Project: AerCap House – MetroLink Submission

Subject: Review of MetroLink Rail Order

Figure 10: Proposed vertical loadings - Bored Tunnel

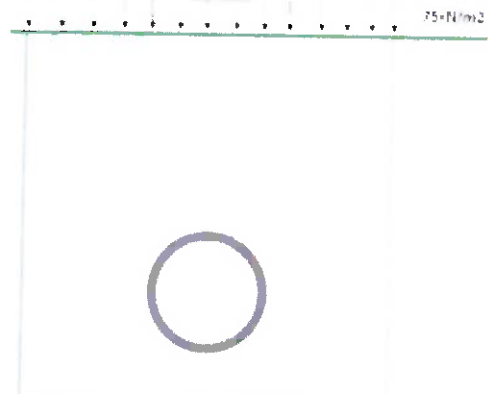
- The tunnel lining design has been prepared on the basis that the bored tunnels are able to carry an over-site load of 75kN/m^2 . The imposed vertical loading for the tunnels is shown diagrammatically in the following.

If this level of load limiting is imposed due to the Metrolink Tunnel, it would not be possible to build a traditional house, let alone extend or rebuild AerCap House, which imposes 1000kN/m^2 at the underside of the foundation level directly above the tunnel.

The conditions imposed by the Metrolink Tunnel would preclude either the vertical extension or future redevelopment of AerCap House, and the exclusion zone would also appear to preclude the deepening of the existing basement level.

We are concerned that TII has not adequately considered the level of foundation loading so close to the Metrolink Tunnel.
